CLIC Civil Engineering and Services

CE Drawings for CDR

- 11 drawings have been circulated for approval via CERN EDMS
- These drawings are now frozen to allowing drafting of CDR and costing exercises
- Some requested changes will be made later during the Technical Design phase

Longitudinal section 1:100'000 / 2000

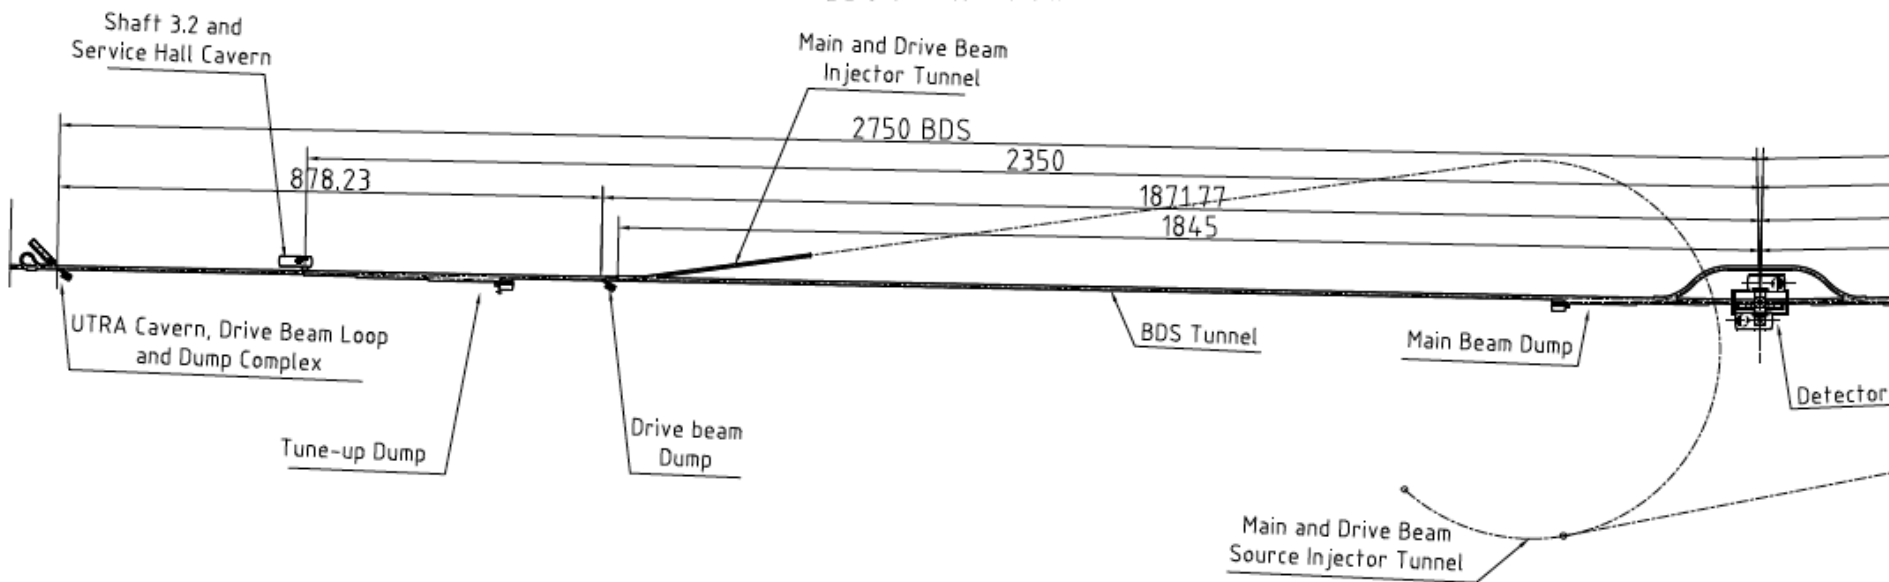
Long profile for CDR agreed in 2010 :

- Laser straight tunnels (not horizontal like ILC)
- Tunnel passes through the Gland depression i.e. same depth as ILC RDR
- 3TeV machine enters into Limestone rock
- Water transfer from lake needs to be removed

CLIC-BDS AREA LAYOUT

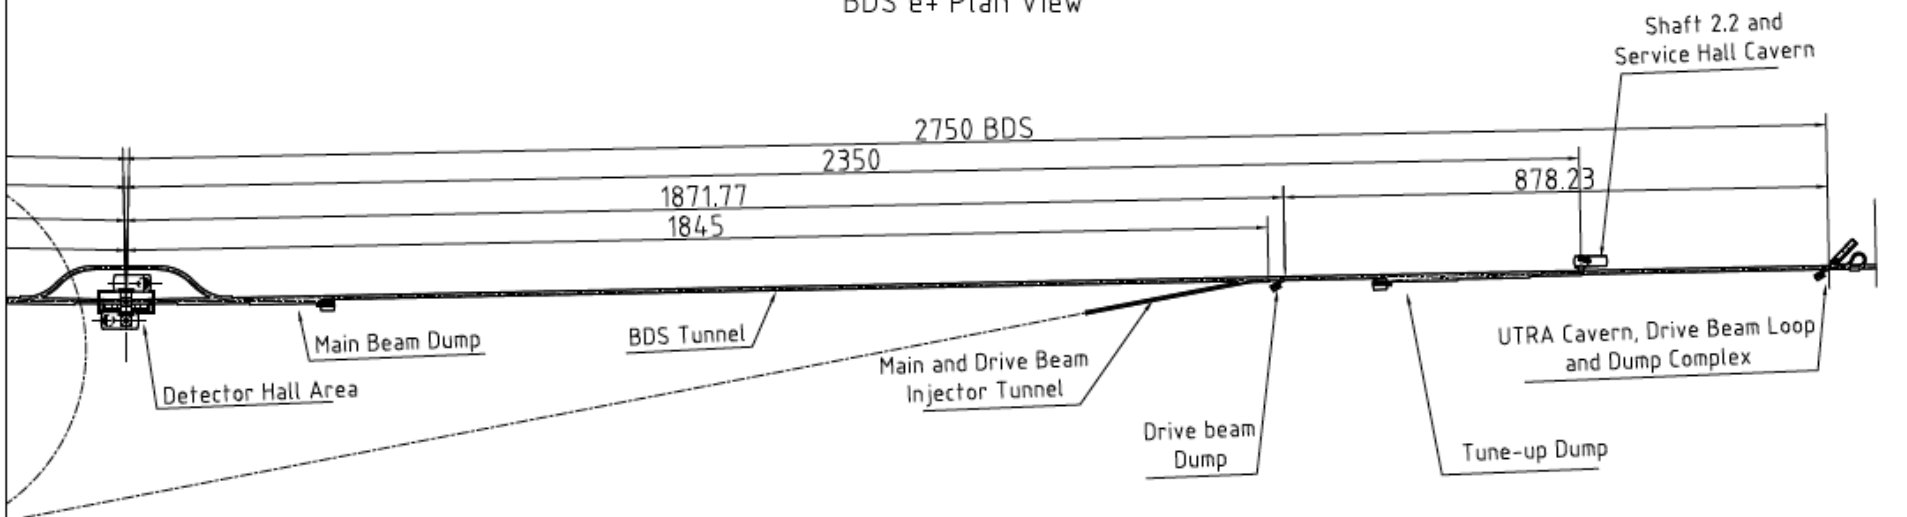
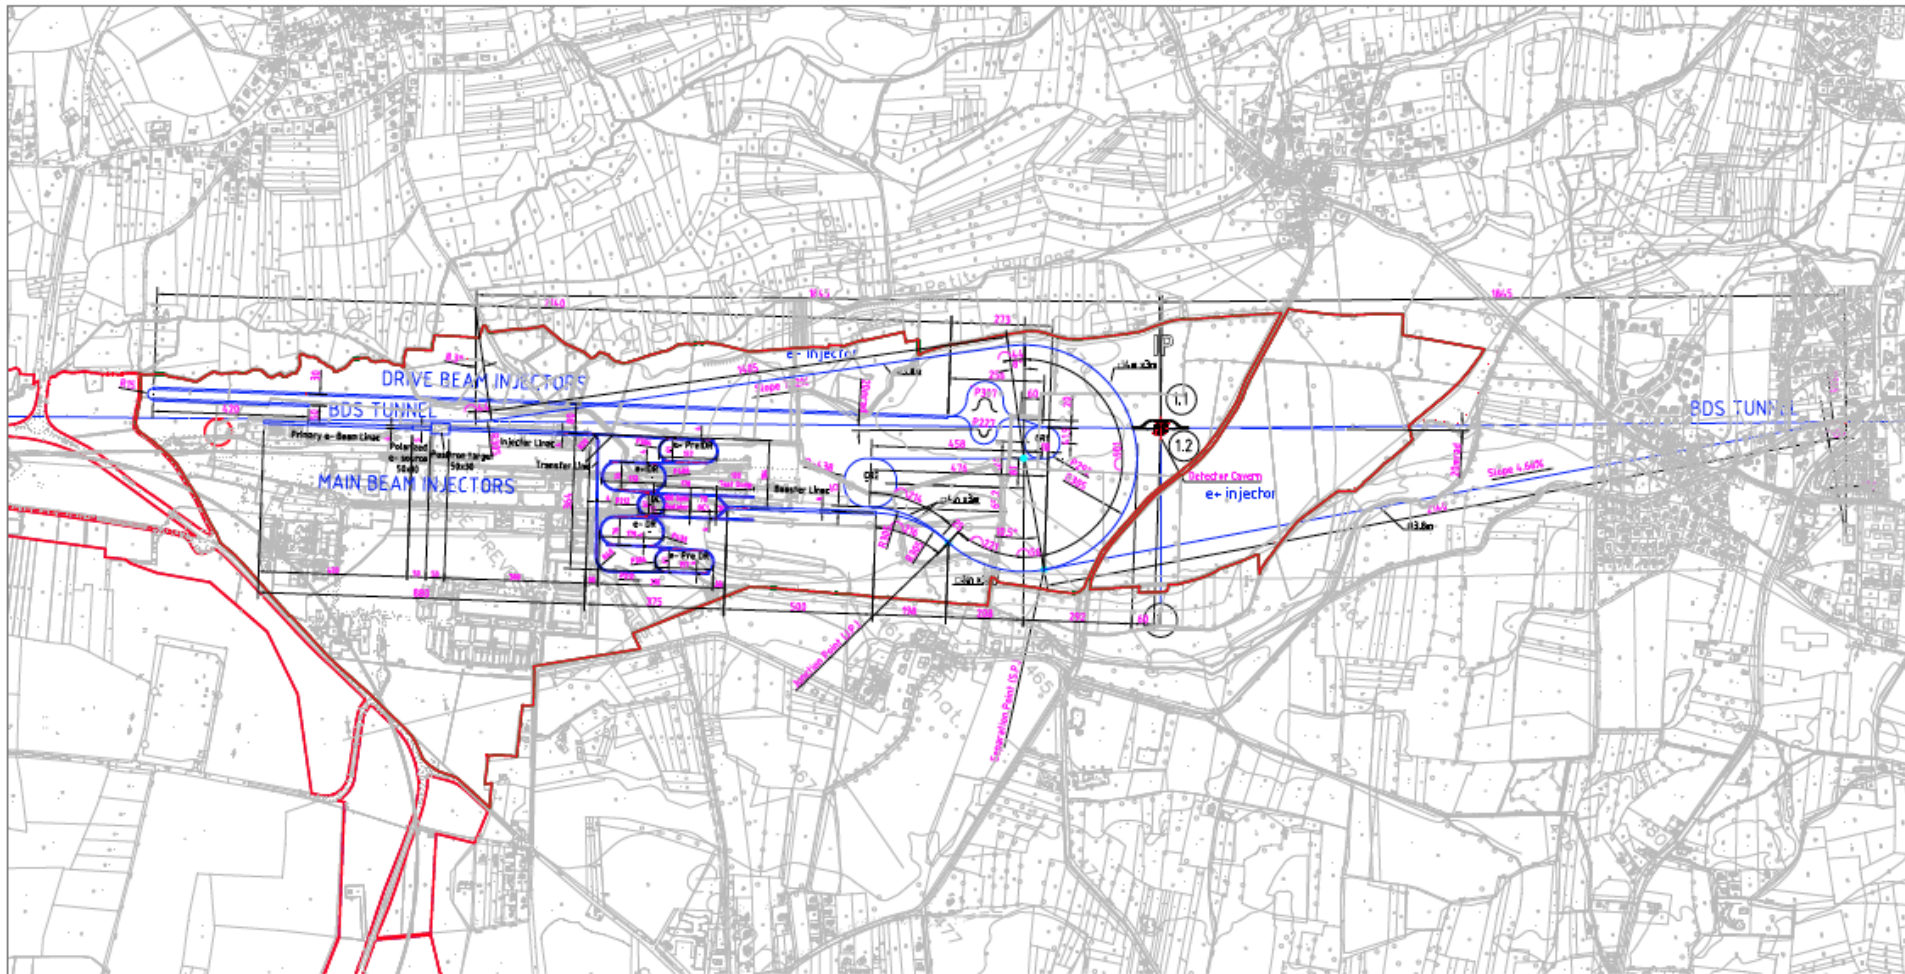
- Turnaround region every 878m
- The size of the facility cavern has increased significantly to host power converter/CV/ EL equipment
- The lengths of the turnaround loops may need to be increased during TDR

CLIC- MAIN / DRIVE BEAM INJECTORS AND EXPERIMENTAL AREA LAYOUT

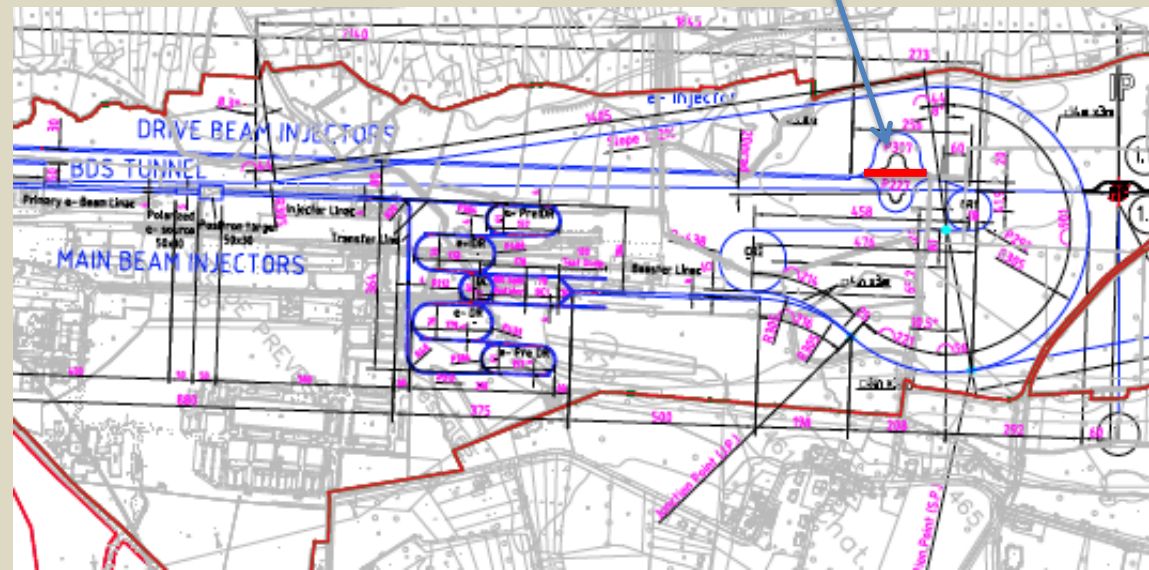
- Red lines set-out the limit of CERN land
- Drive beam injection line to be added

CLIC-ML SHAFT (9m-3t Lift) CROSS SECTION

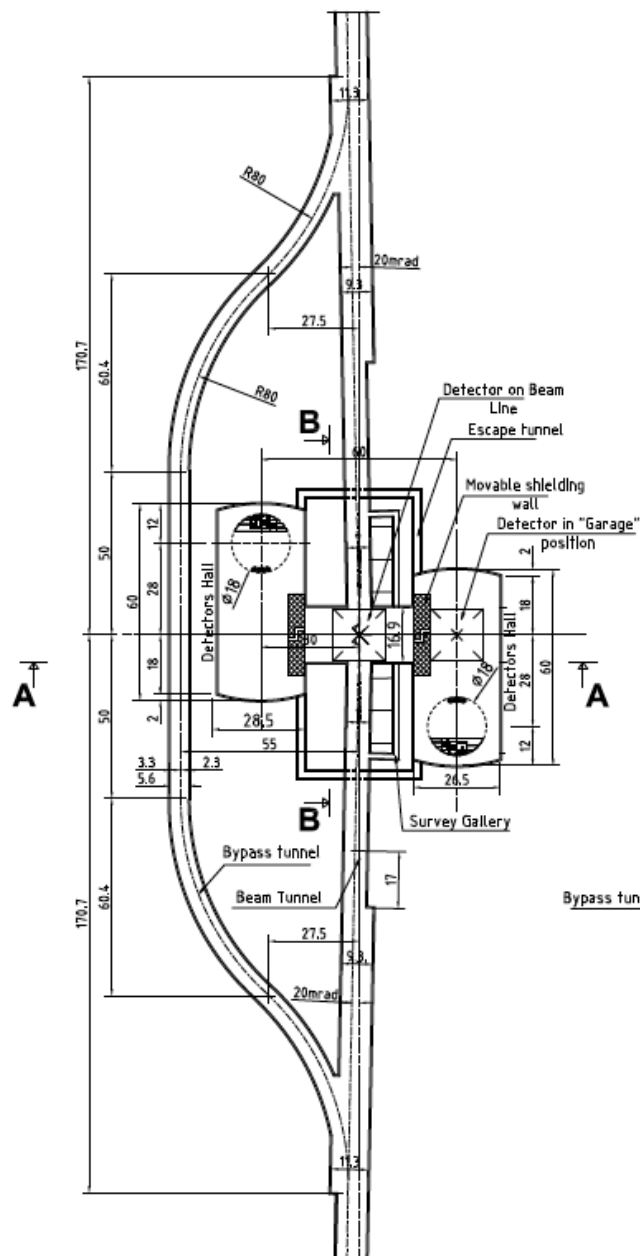
- Typical cross section for 9m diameter shaft found every 5 km
- Based on LHC design

CLIC- DETECTORS HALL AREA (SURFACE AND UNDERGROUND)

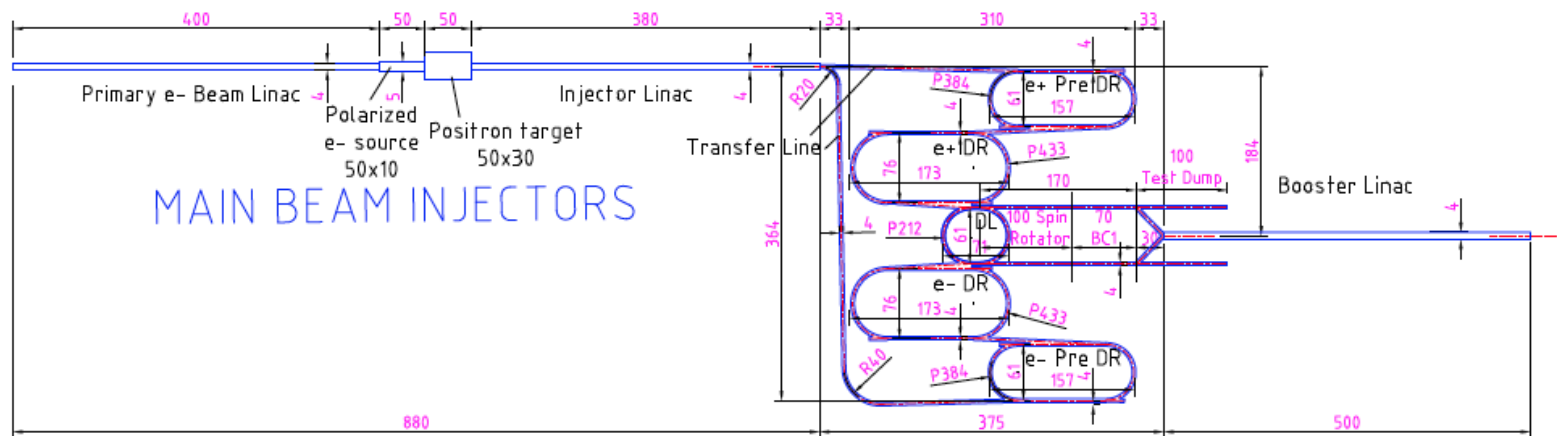
- Bypass tunnel now out of the volume of the detector assembly cavern
- Shielding doors to remain as a place holder, detector could be self shielded
- Wall alongside shielding doors have to be flat
- Safety galleries for both caverns have been added
- 2x80t cranes on surface + 2x20t cranes underground, based on CMS site

CLIC- MAIN BEAM INJECTORS DELAY LOOP LAYOUT

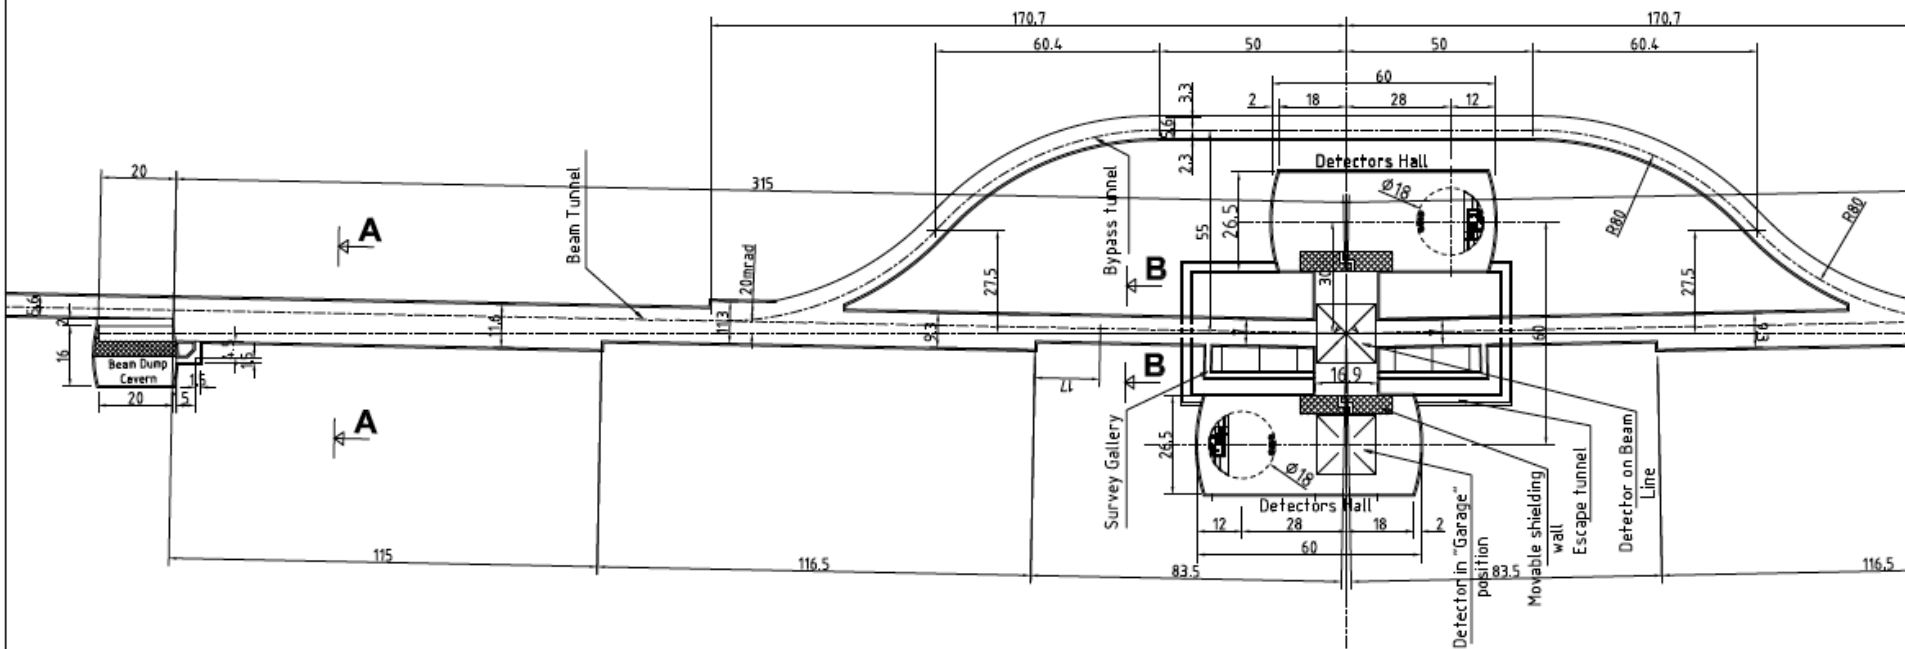
- Many changes were introduced but design is now converging

CLIC-BDS MAIN BEAM DUMPS

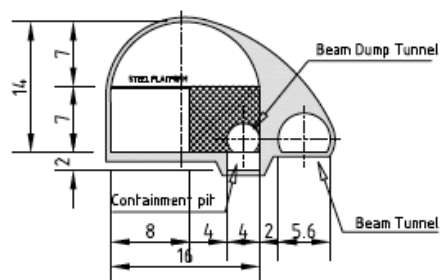
- BDS length was changed because the tunnel got wider. If we want to maintain a 2m thick shielding at the Beam dump cavern, the BDS has to become longer
- No other changes can be envisaged for the CDR
